CITY OF ALBUQUERQUE

**Re: Starbucks
1000 Rio Grande NW
Request 30-Day Temporary C.O. - Accepted
Engineer's Stamp dated: 6-17-15 (H13D021)
Certification dated: 3-24-16**

1000 AND 1010 RIO GRANDE BLVD., NW GRADING AND DRAINAGE PLAN

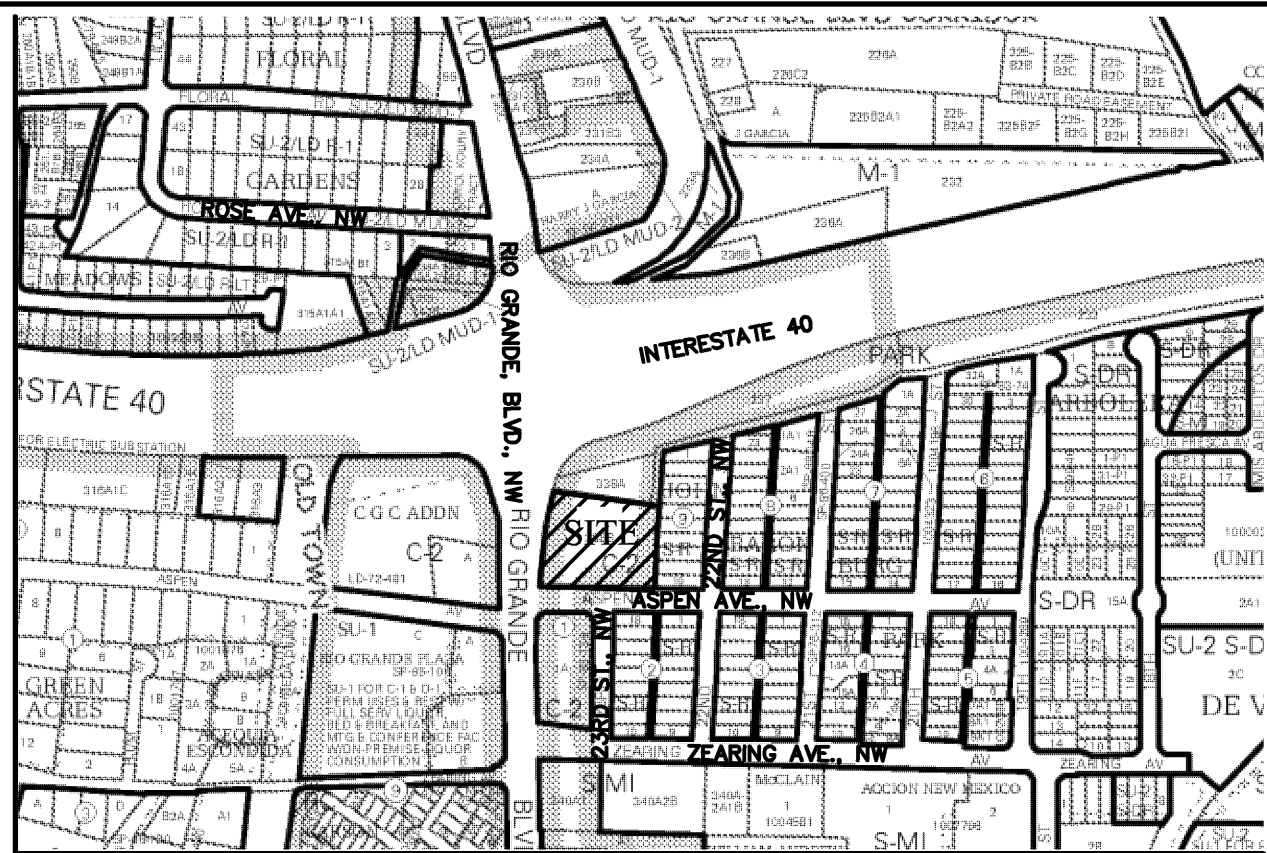
- The sidewalk on the south side of the building was not as-built on the drawings. Sidewalk is blocking flows to pond. Provide pipe underneath or sidewalk culvert.
- Transformer is on a mound that is diverting flows to the south and not into pond 'A'. A landscape water valve box is blocking flows into pond 'A'.

An inspection by our office will need to take place after these corrects are made.
